STATE OF NORTH CAROLINA
DEPARTMENT OF TRANSPORTATION

August 14, 2008

Subject: **Application for Modification to Individual Permit** for NC 16 from north of SR 1386 in Lincoln County to North of SR 1895 in Catawba County. Federal Aid Project No. STP-F-24-1(34) State Project No. 8.1830501. **TIP Project No. R-2206B/C.** \$570.00 Debit from WBS Element No. 34383.1.5.

-  DENOTES FILL IN WETLAND
-  DENOTES EXCAVATION IN WETLAND
-  DENOTES MECHANIZED CLEARING
-  DENOTES IMPACTS IN SURFACE WATER
-  DENOTES IMPACTS IN SURFACE WATER (POND)

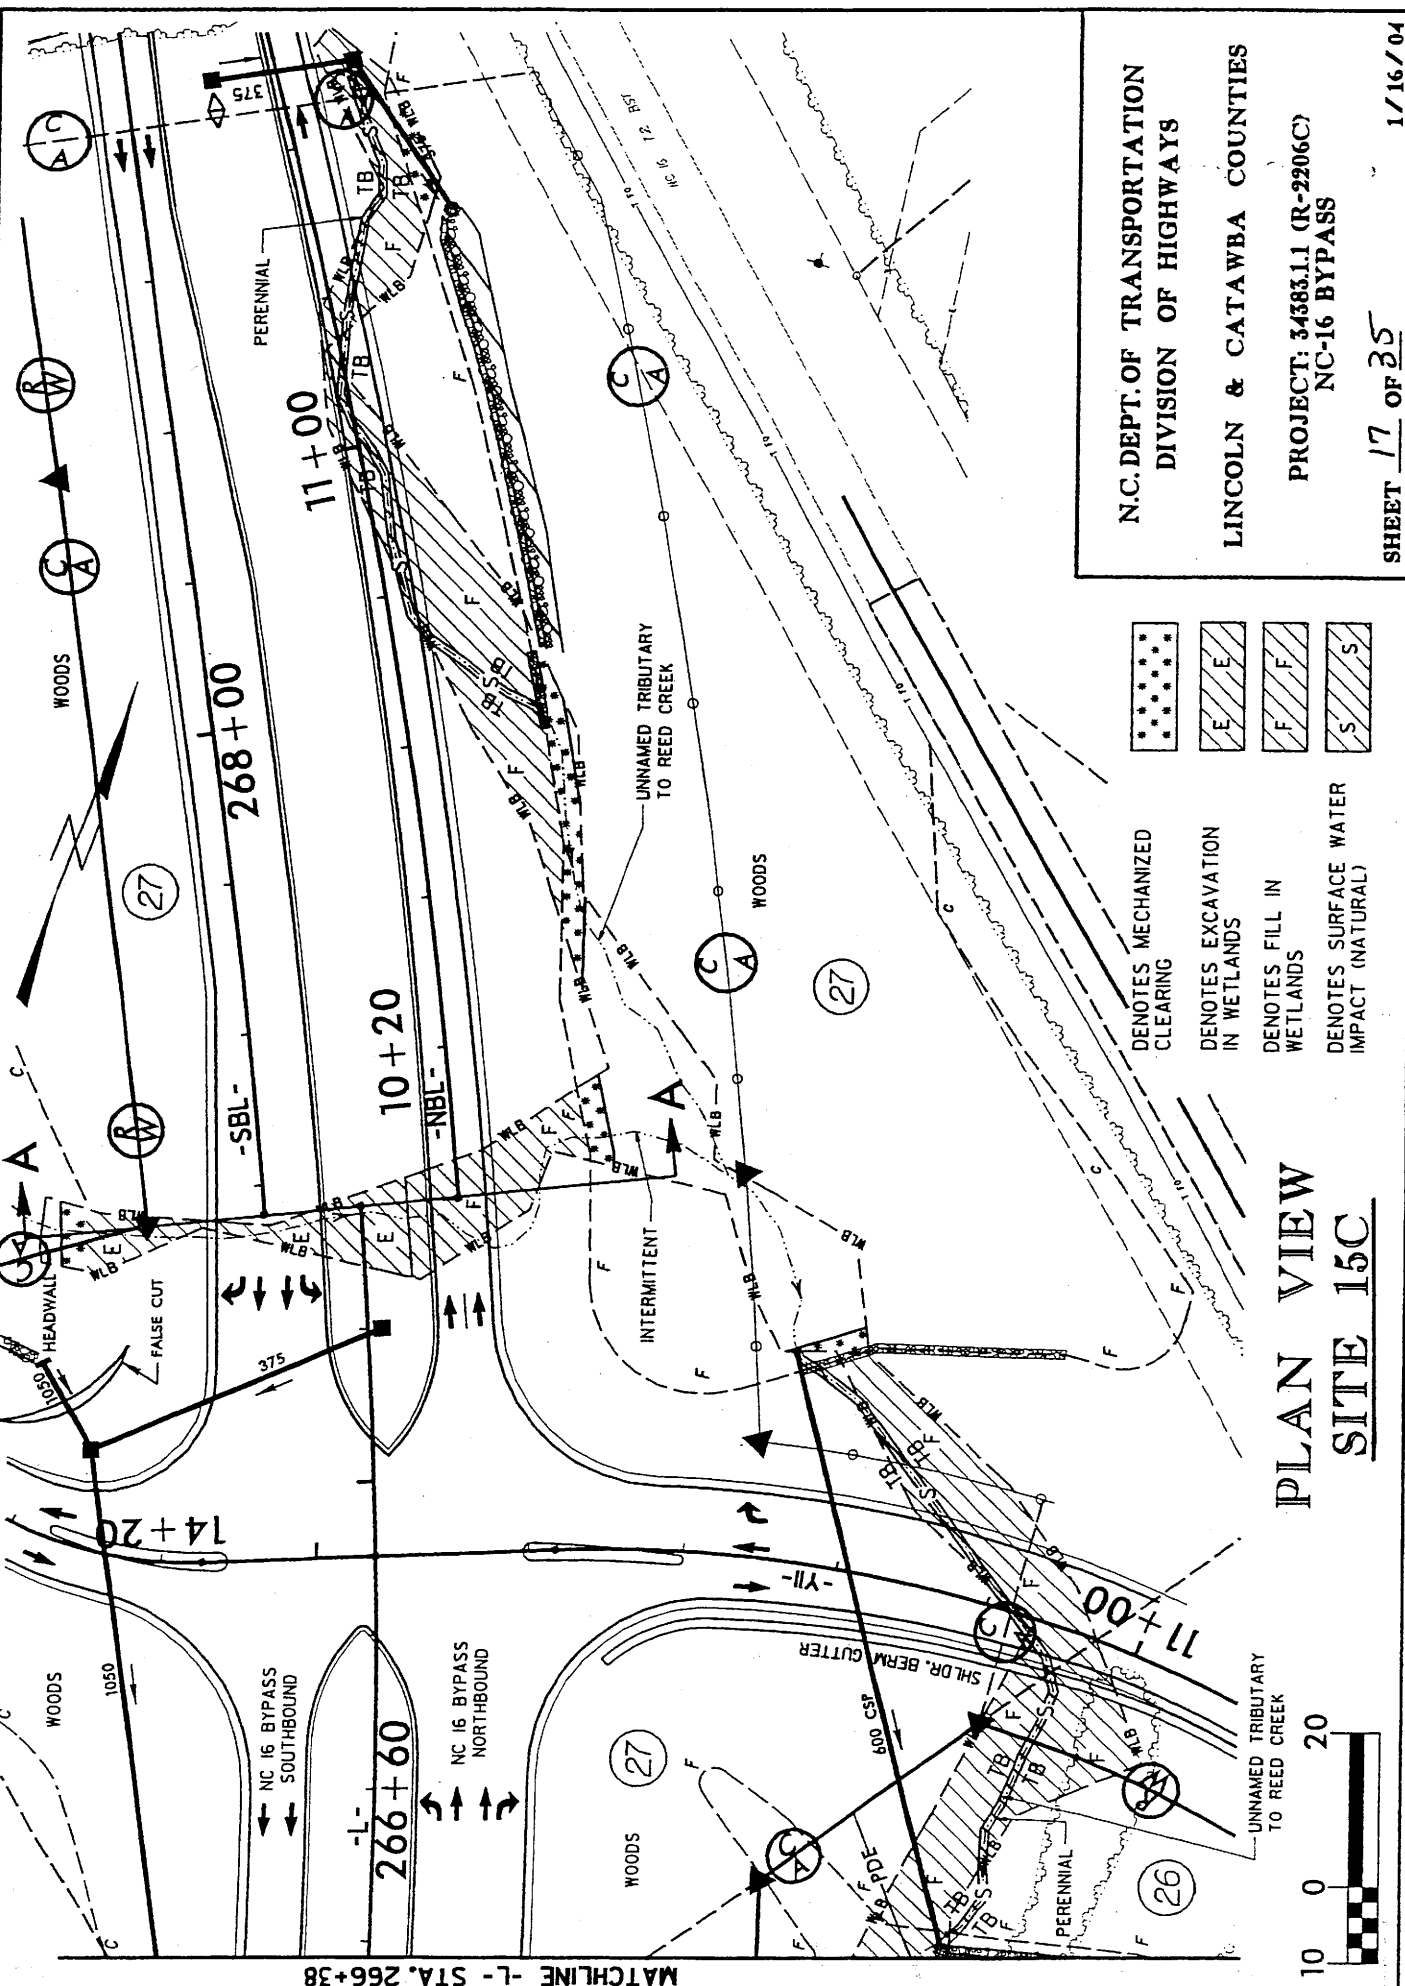
Permit Site 15C, Station -L- 267+70 to 11+54-L-RT

To improve the stability of the ditch at this site, NCDOT has re-designed the ditch from a V-ditch originally permitted to a Lateral Base Ditch. There is no change to the permanent wetland or stream impacts at this site associated with the re-designed ditch. There are 82 feet of temporary stream impacts to an unnamed tributary (UT) to Reedy Creek associated with tying in the ditch. The temporary impacts are depicted on Mod Sheets 2 & 3 of 5, and require no mitigation.

Temporary Impacts: 82 linear feet of temporary stream impact not previously accounted for.

MODIFICATION
 Permit Drawing
 Sheet 4 of 5
 (revised JUNE 2008)

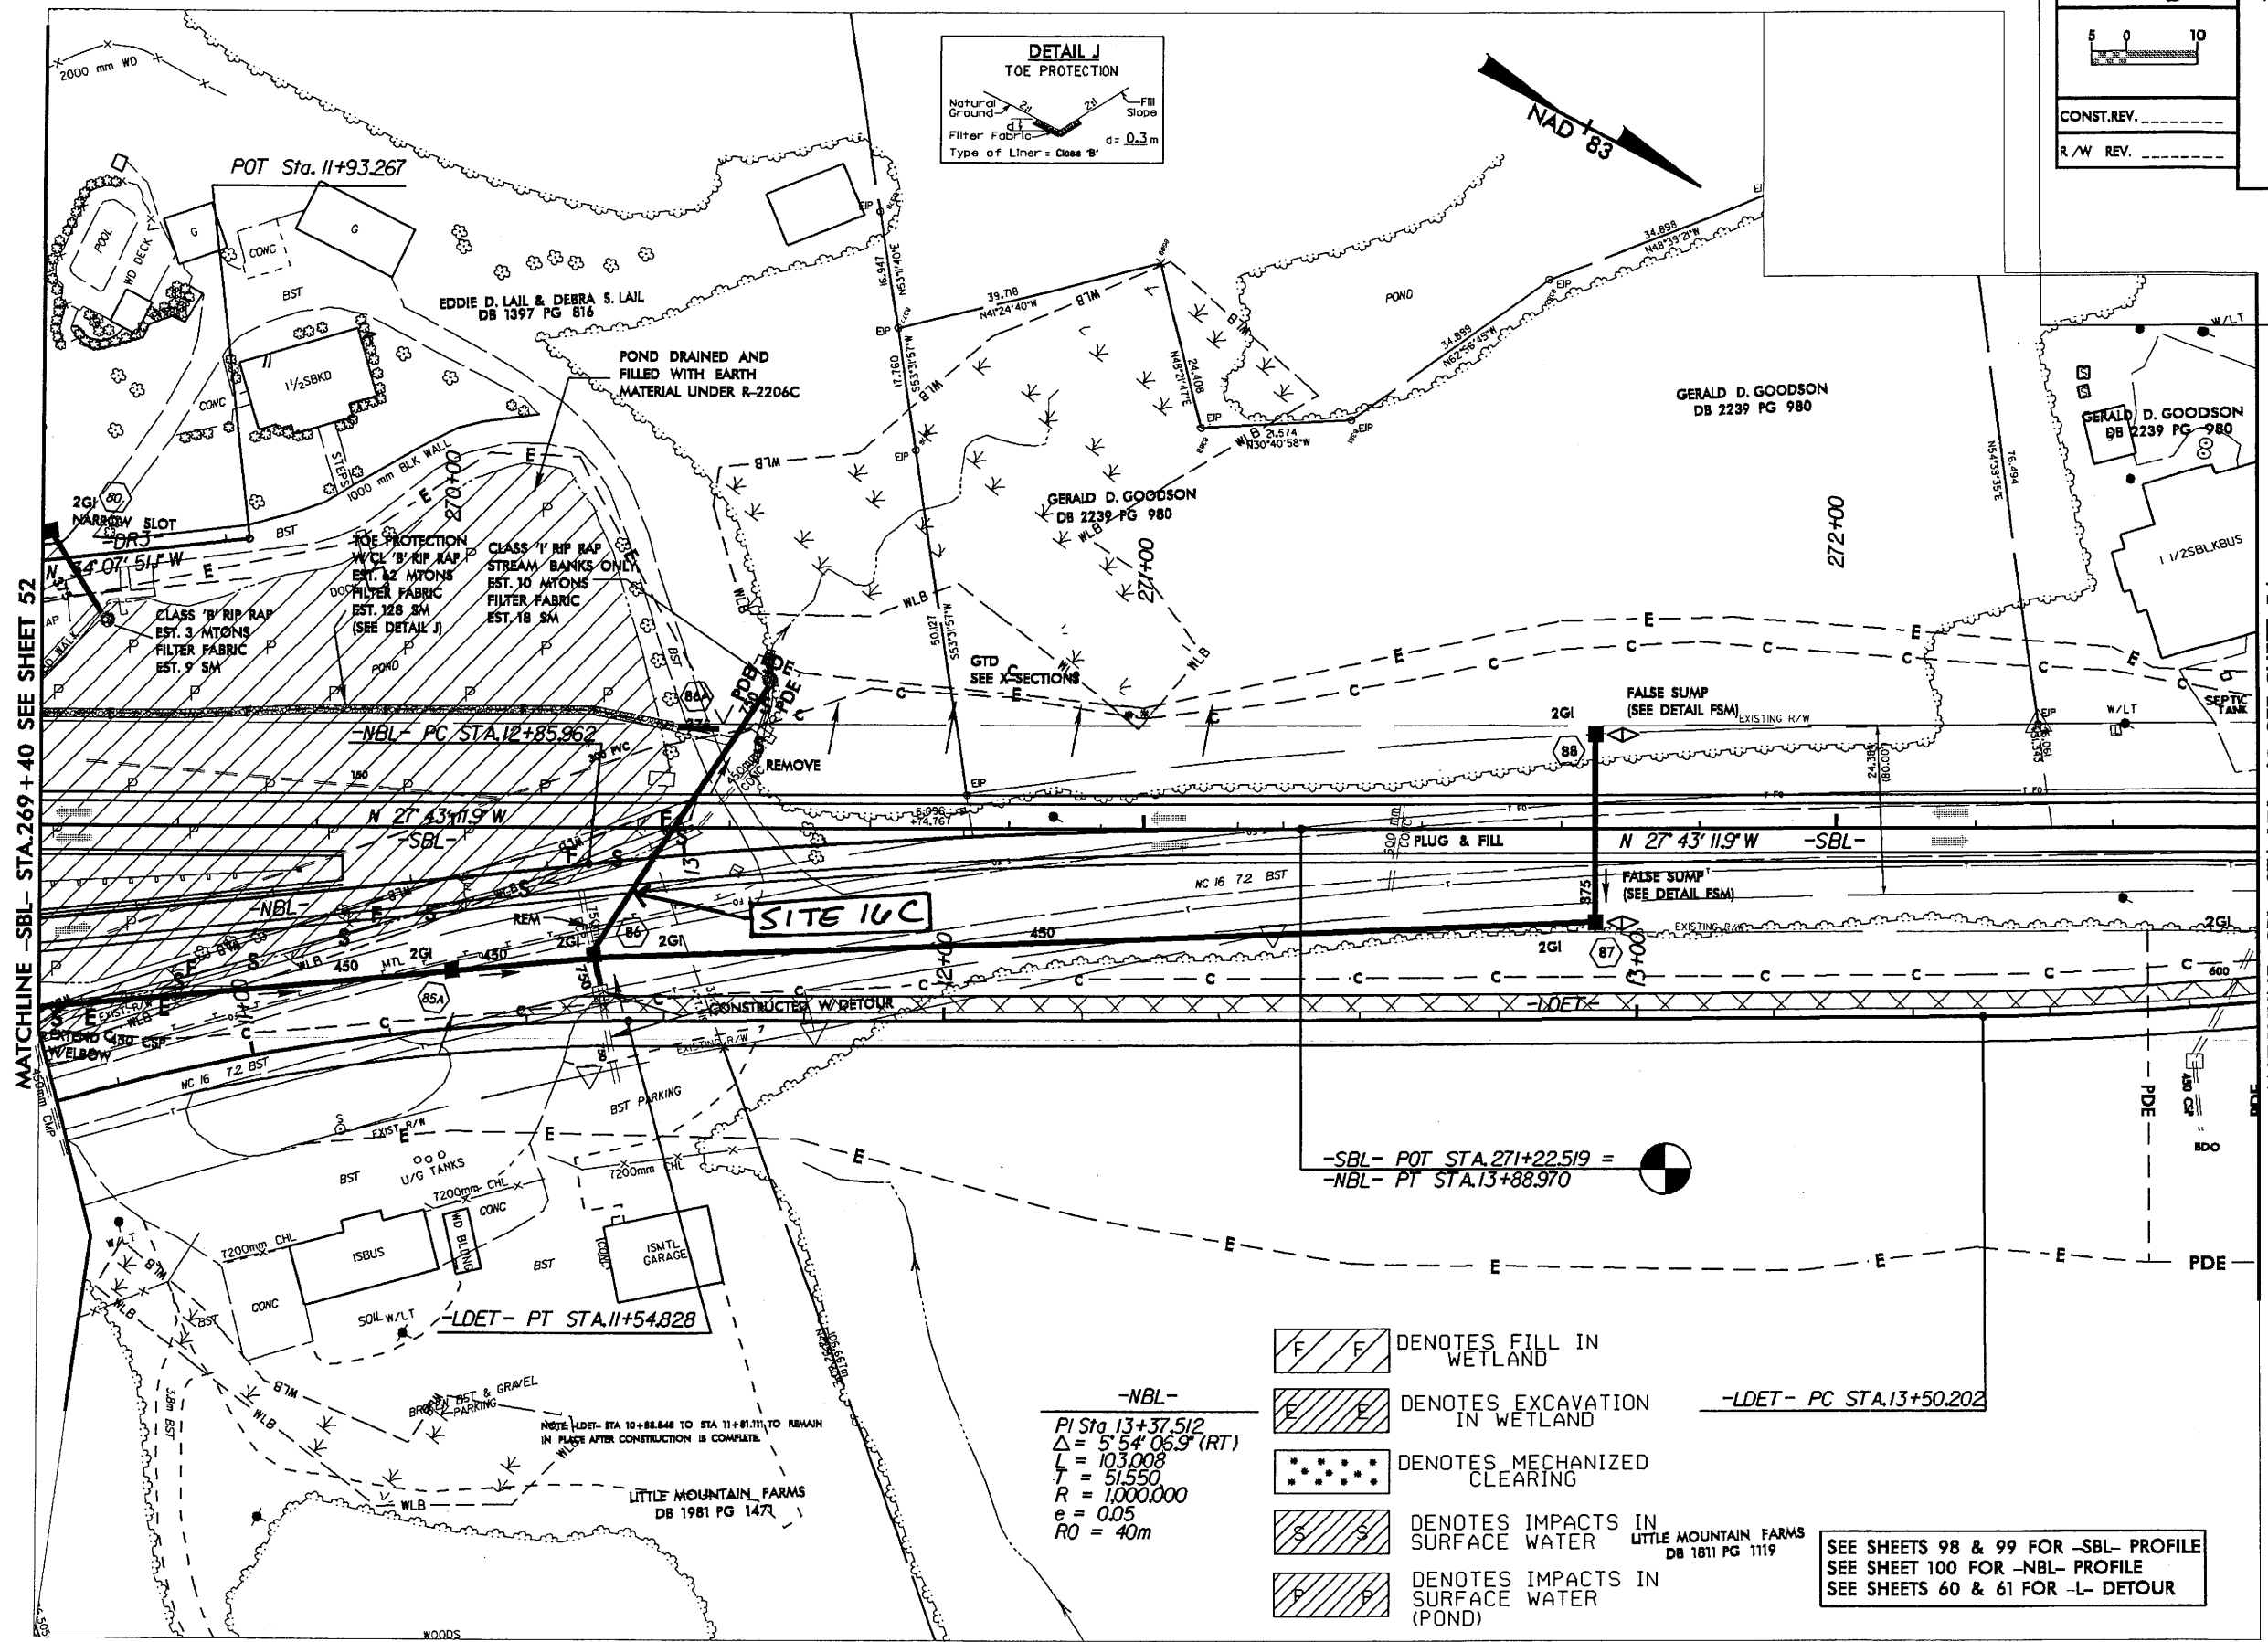
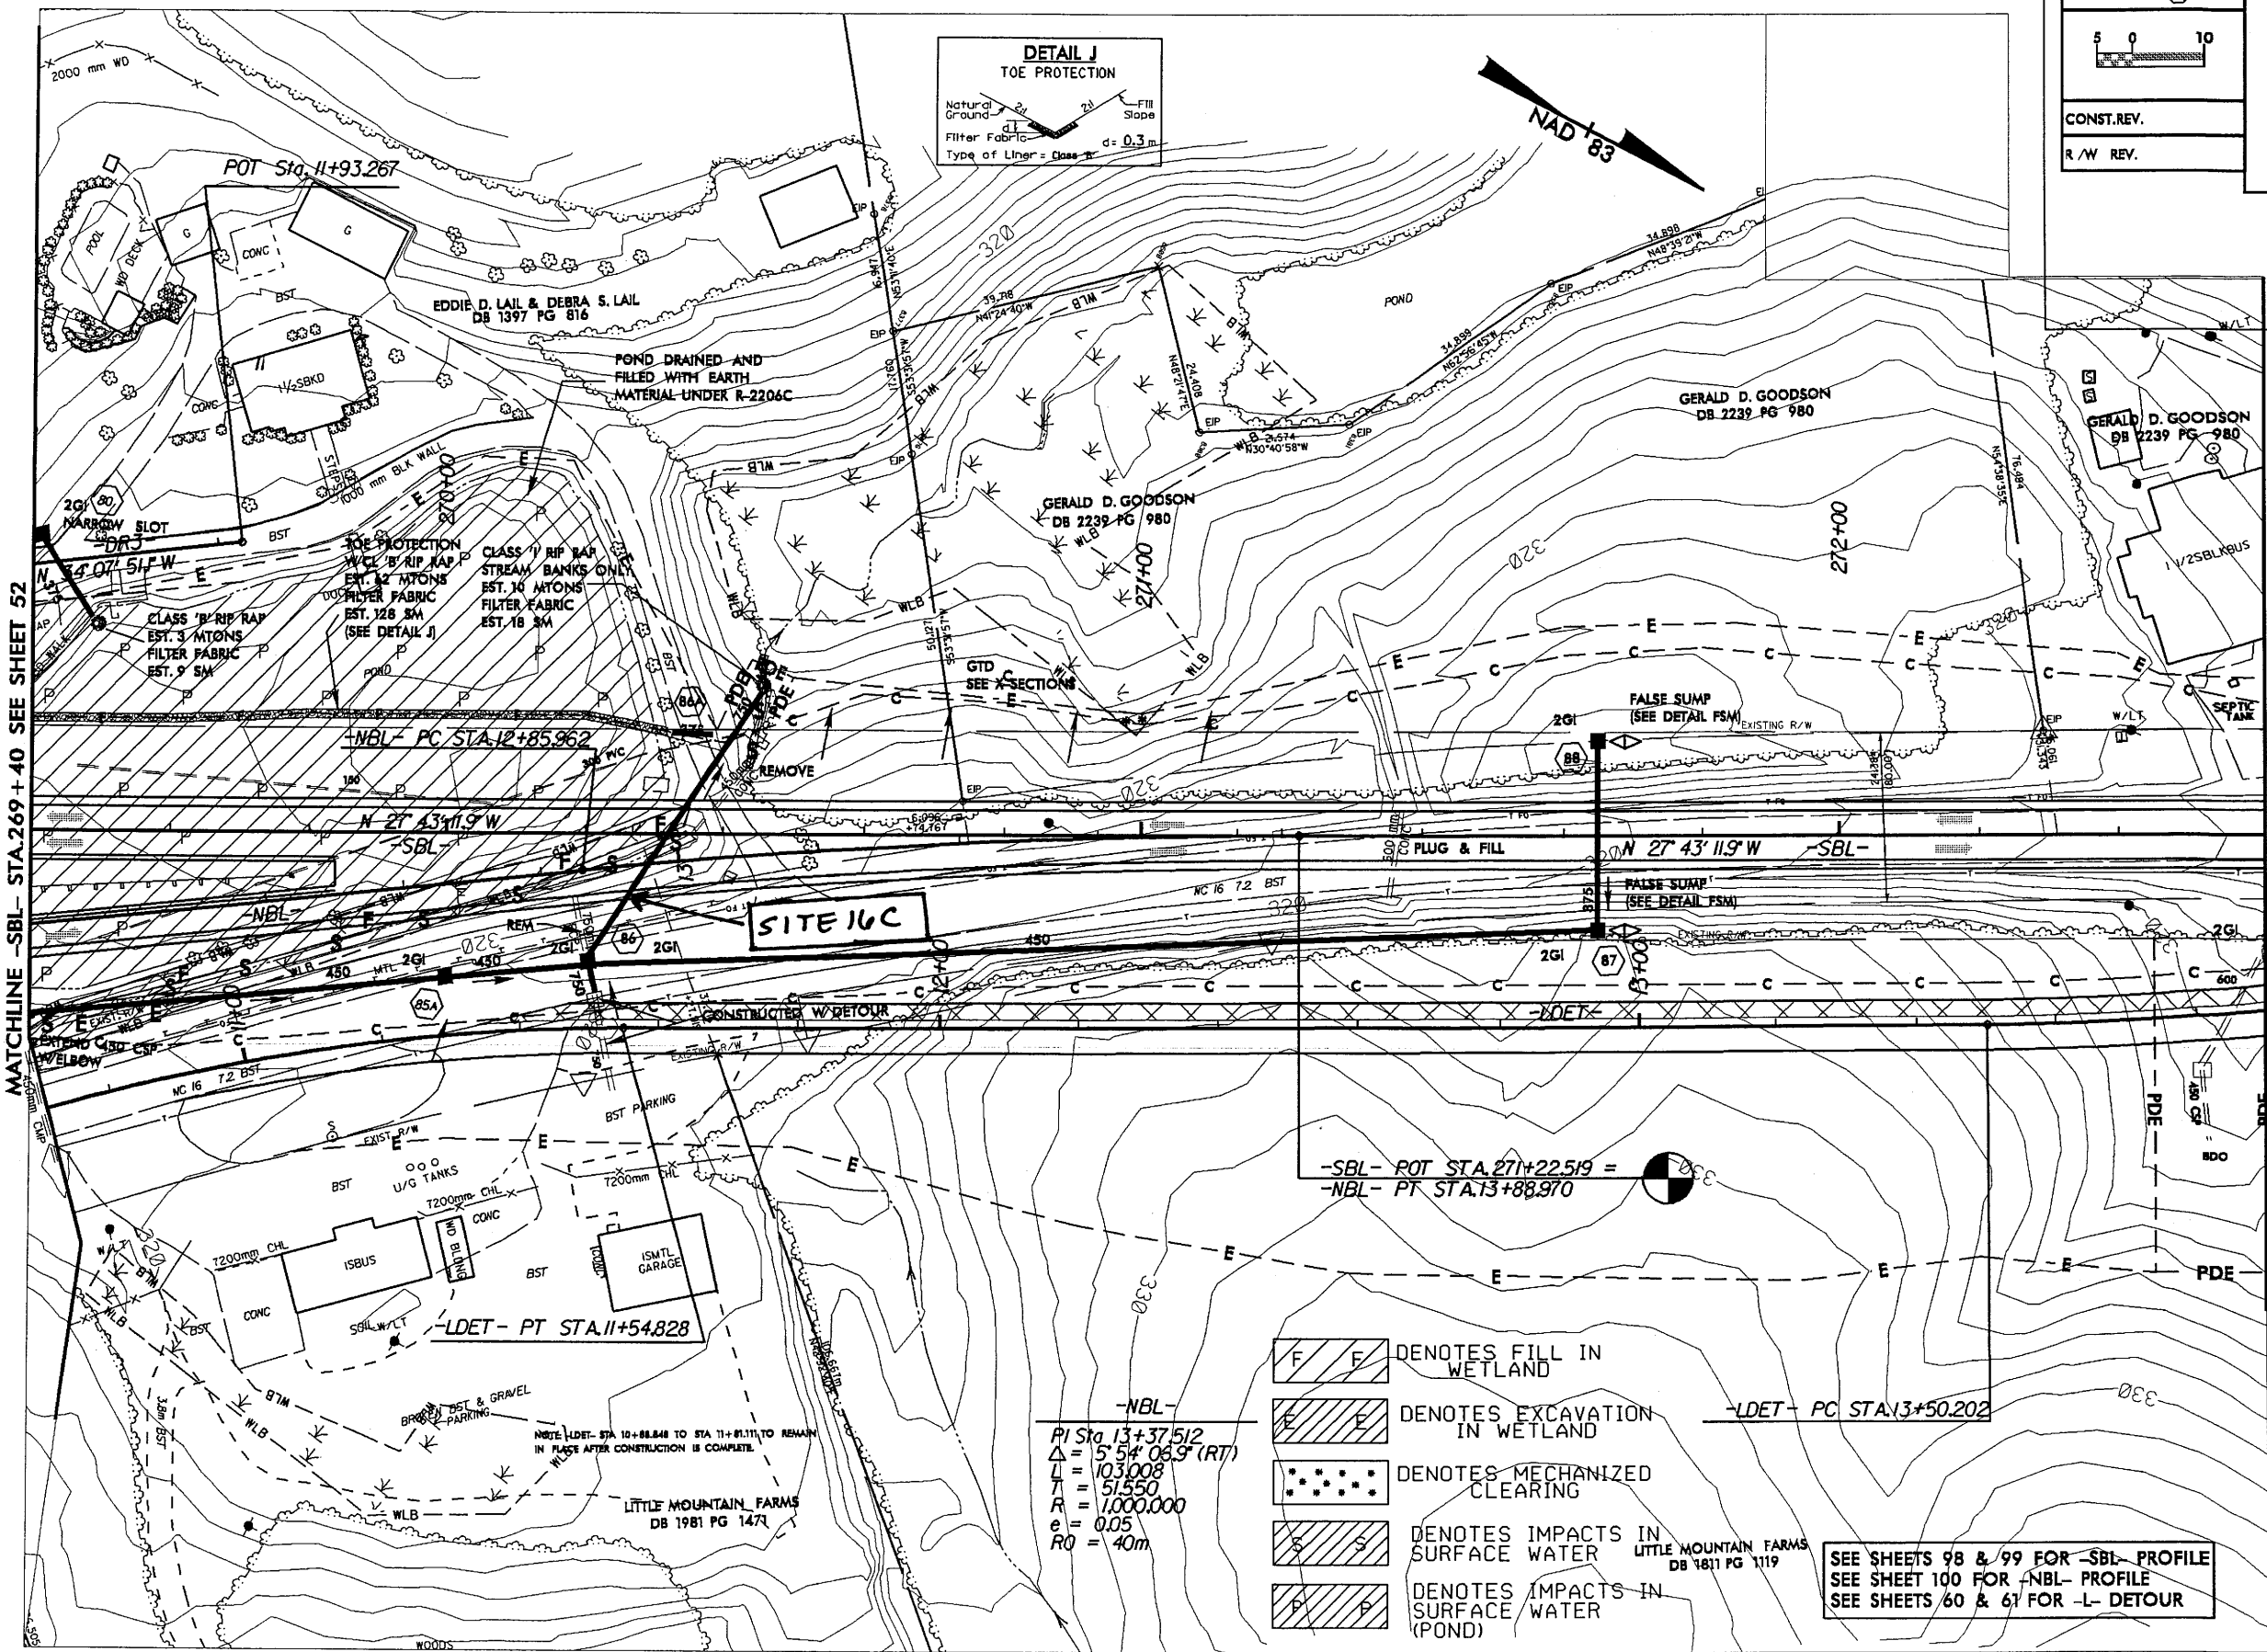
Permit Site 16C, Station 270+32-L

To incorporate a drainage system revision, a 30-inch (750mm) reinforced concrete pipe (RCP) will be installed in place of the 24-inch (600mm) RCP originally permitted (Mod Sheets 4 & 5 of 5). There are no additional temporary or permanent impacts associated with this change in pipe size.
